Cambridge Waste Water Treatment Plant Relocation Project  
Anglian Water Services Limited

# Appendix 4.1: Scoping Opinion

## **Proposed Cambridge Waste Water Treatment Plant Relocation**

**Case Reference: WW010003**

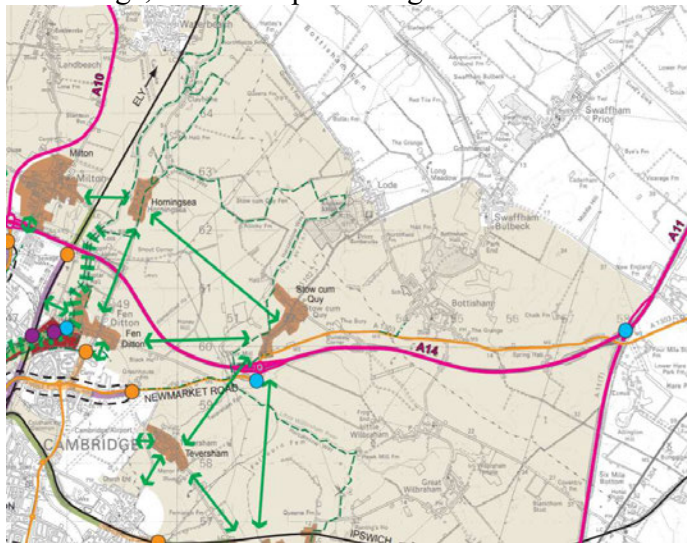
We object to AW's suggestion that a 22-hectare sewage works, lit at night, with several tanks up to 26 m high could be constructed above ground without it dominating the south-western gateway to the Vision and thereby completely destroying it. The tallest structures would rise above the trees and be visible for a considerable distance.

CPRE suggest that this area experiences an up lighting at night of only 1 to 2 nanowatts/cm<sup>2</sup>. One of our residents was able to photograph a wonderful tranquil

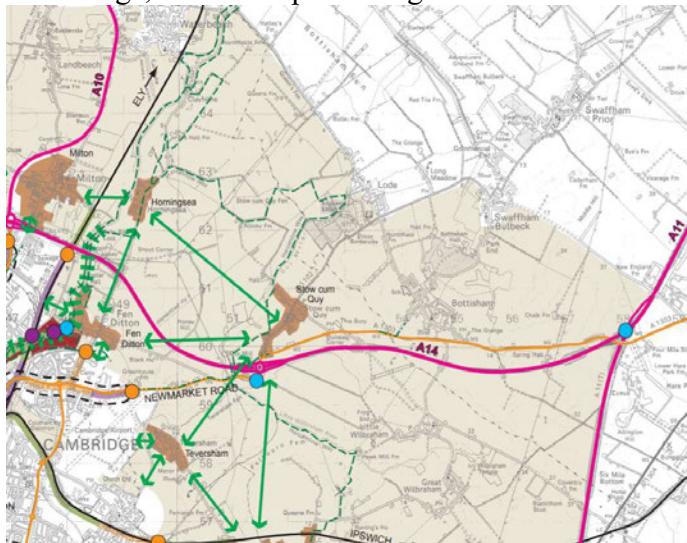
We object to AW's suggestion that a 22-hectare sewage works, lit at night, with several tanks up to 26 m high could be constructed above ground without it dominating the south-western gateway to the Vision and thereby completely destroying it. The tallest structures would rise above the trees and be visible for a considerable distance.

CPRE suggest that this area experiences an up lighting at night of only 1 to 2 nanowatts/cm<sup>2</sup>. One of our residents was able to photograph a wonderful tranquil
